STAFF REPORT

BARTHOLOMEW COUNTY PLAN COMMISSION (April 9, 2014 Meeting)

Docket No. / Project Title: MIP-14-03 (Medaris – Mullen Minor Subdivision)
Staff: Thom Weintraut
Applicant: M. Kyle Medaris
Property Size: 25.80 Acres
Current Zoning: AG (Agriculture: General Rural)
Location: 12720 West 525 South, in Ohio Township

MEDARIS - MULLEN MINOR SUBDIVISION

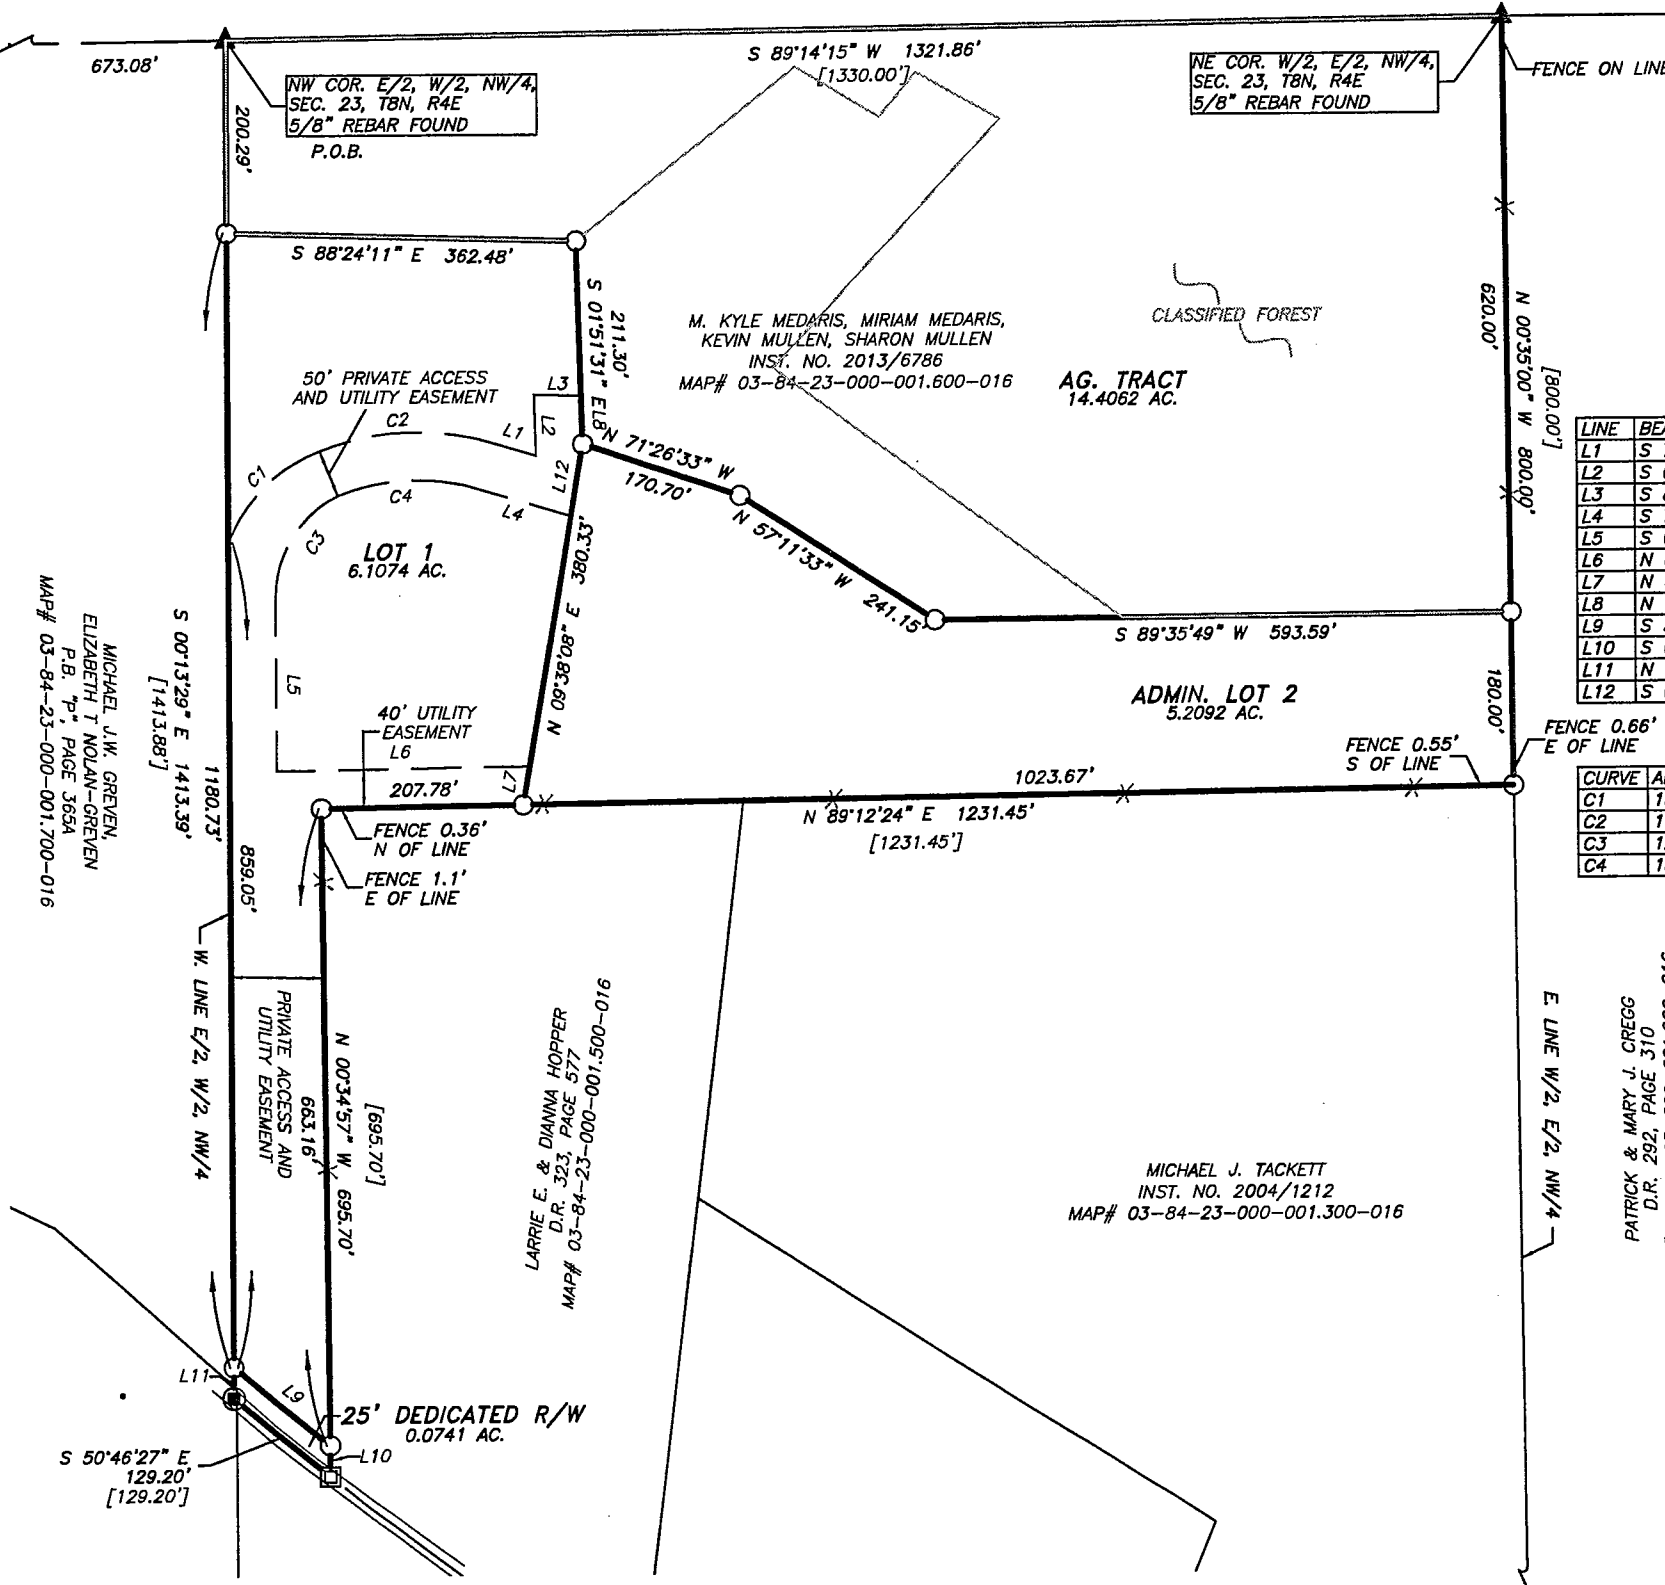
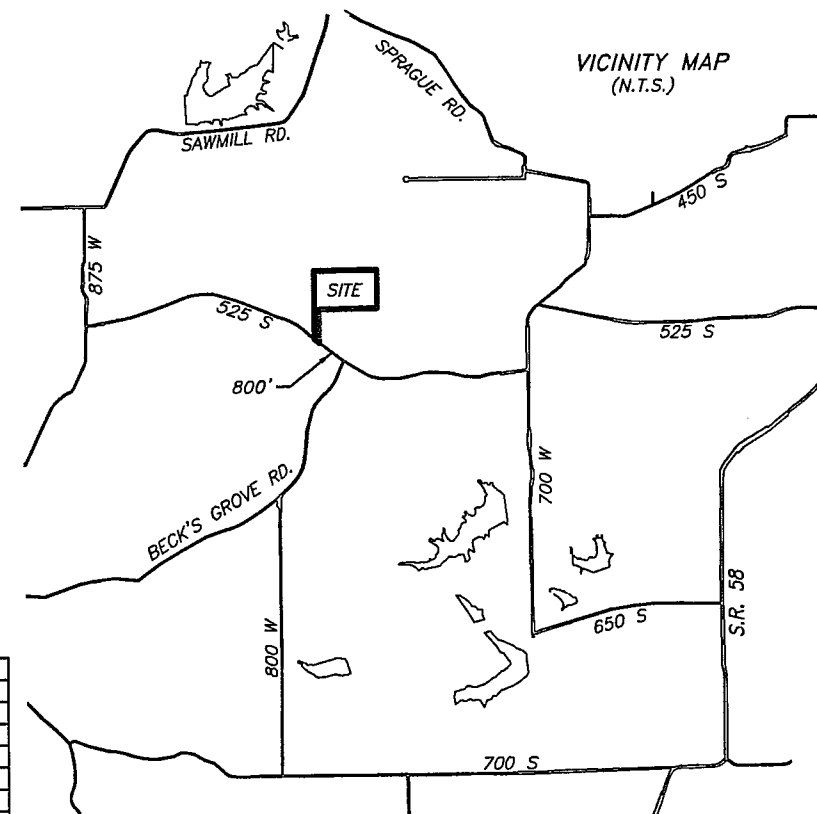
1. Label the Ag. Remainder as Agriculture Remainder.
2. Provide a signed agriculture affidavit.
3. Plan Commission Certificate should list President, Zack Ellison – then Secretary, Tom R. Finke
4. Meet the requirements for clearing the site visibility triangle agreed upon at the March 27, 2014 meeting with the County Highway Department.

2. The access easement shown on the plat follows the existing driveway and divides lot 1 in to two sections. The portion of the property to the north of the easement is where the applicant wishes to construct the new residence, however there is not sufficient room to located two required septic sites and therefore septic sites are located on the portion of the lot south of the easement. The portion of the lot south of the easement contains the pond which limits locating a house and two septic sites.

5. The current lot is a flag shaped lot and the length of the driveway to the existing house is approximately 1650 feet. Since the driveway does not have two points of access to a public road, its length shall meet the requirements for a cul-de-sac, which is a maximum distance of 1000 feet. The proposed lot arrangement creates a corridor that exceeds 1200 feet in length and because of the location of the pond there is not a feasible alternative location that would be less than 1000 feet.

1. The applicant shall provide a pullover area with a minimum pavement width of 16 feet midway between County Road 525 South and the first curve of the access easement.
2. The applicant shall provide an additional pullover area with a minimum pavement width of 16 feet at the location of the access easement leading to the Agriculture Remainder.
3. Resolve any outstanding technical comments.

MEDARIS – MULLEN MINOR SUBDIVISION (SIGNIFIGANT FEATURES)

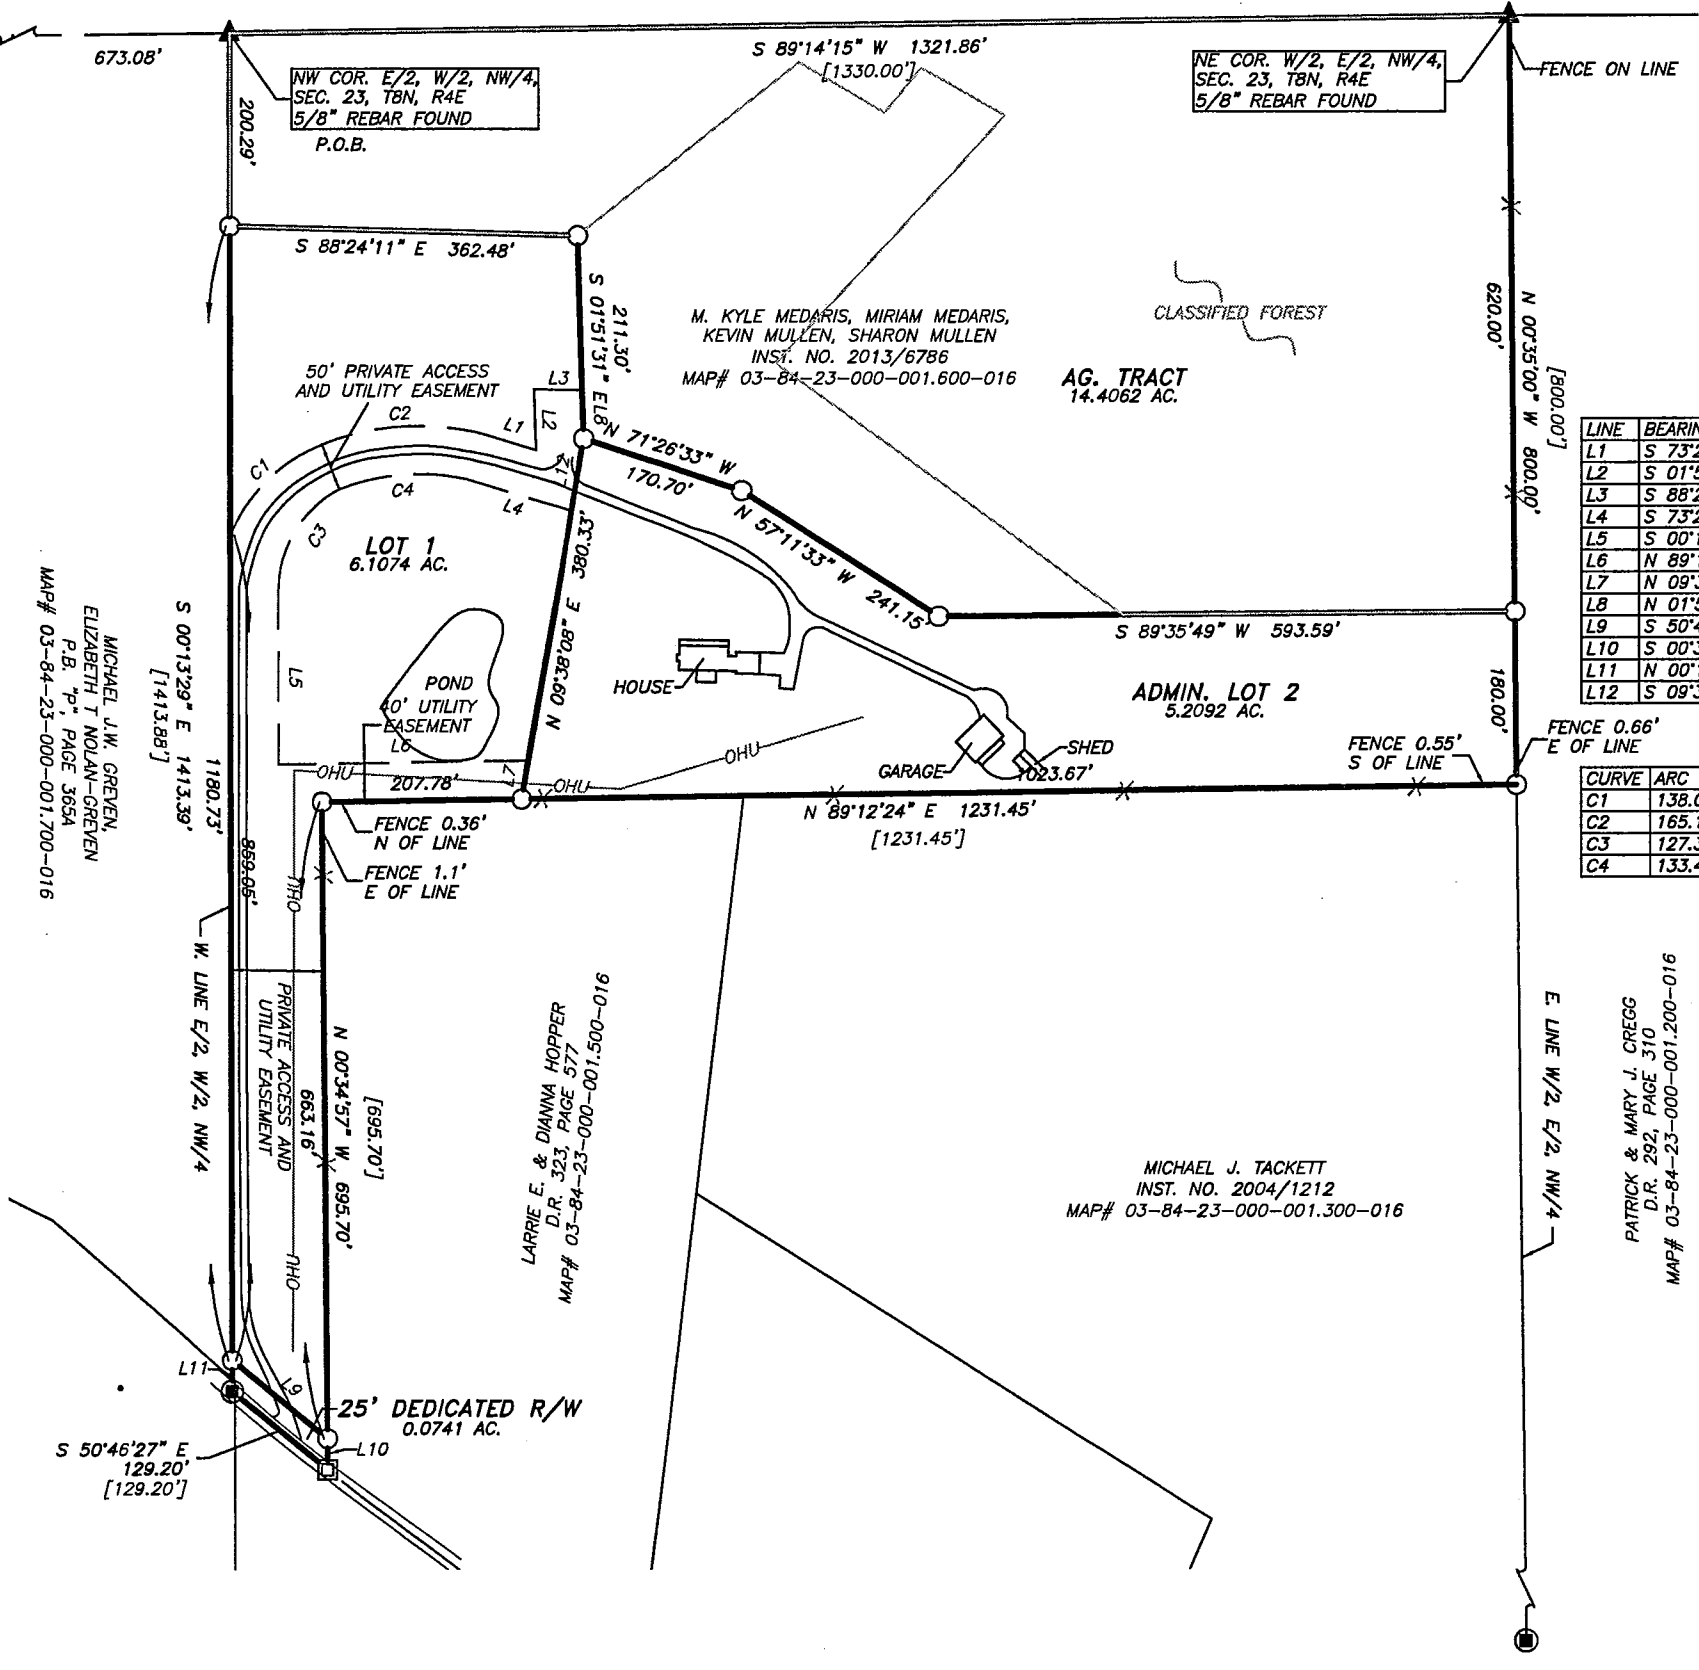
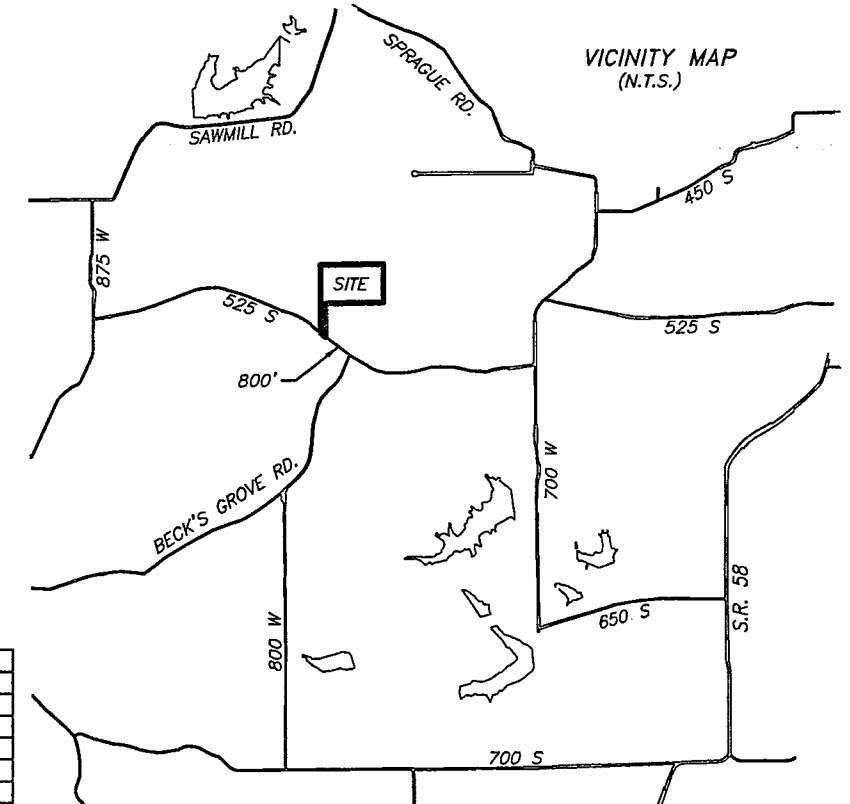
1. The area labeled as the Agriculture Remainder is heavily wooded and a large portion is a classified forest. The applicant states the classified forest will be timbered in the future and would consider timbering as harvesting of a crop. The northern portion also has steep grades that fall to the northeast thus limiting the potential locations for new building sites.
